Access Compliance Report Public Rights-of-Way (Curb Ramps)

Main Street: N_WRIGHTWOOD_ST Cross Street: SPRING_ST Location: NE

ADA ID: RPAT210927111513 Ramp Type: Type 1 - Perpendicular Diagonal Initial Pass/Fail: Fail Overall Compliance: No Severity Score: 15

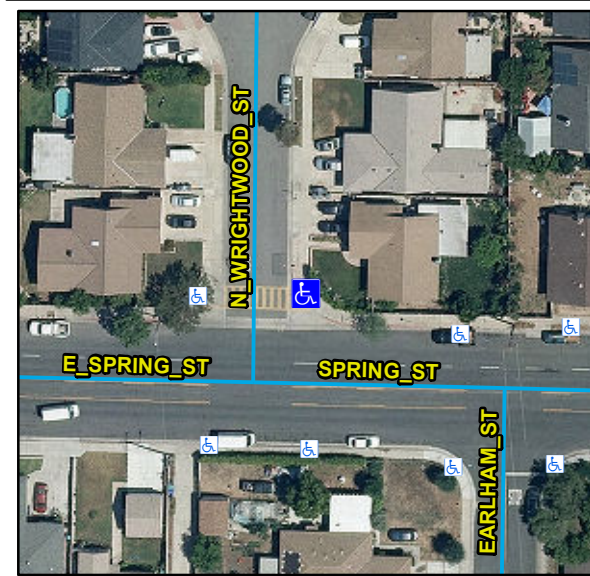
Compliance	Description	Data	Compliance	Description	Data
N/A	Ramp Length (in)	78	N/A	Flare Type LT	
Yes	Ramp Width (in)	50			N/A
No	Ramp Run Slope (%)	10.6	N/A	Flare Slope LT (%)	N/A
Yes	Ramp Cross Slope (%)	1.5	N/A	Flare Traversable LT	N/A
N/A	Landing Present	N/A	N/A	Flare Type RT	
N/A	Landing Length (in)	N/A			N/A
N/A	Landing Width (in)	N/A	N/A	Flare Slope RT (%)	N/A
N/A	Landing Run Slope (%)	N/A	N/A	Flare Traversable RT	N/A
N/A	Landing Cross Slope (%)	N/A	N/A	DWS Provided	N/A
N/A	Landing Movement Obstructed?	N/A	N/A	DWS Contrast	N/A
	Landing Movement Type	N/A	N/A	DWS Length (in)	N/A
N/A	Landing Shared	N/A	N/A	DWS Full Width	N/A
N/A	Clear Space	Yes	N/A	DWS Offset Left (in)	N/A
N/A	Clear Space To Crosswalk (in)	N/A	N/A	DWS Offset Right (in)	N/A
N/A	Marked Crosswalk 1	Yes	N/A	Marked Crosswalk 2	No
	Crossing 1 Direction	W		Crossing 2 Direction	S
	Marked Crosswalk 1 Width (in)	120		Marked Crosswalk 2 Width (in)	N/A

Remove & Replace Curb Ramp With Two New Directional Ramps or Equivalent.
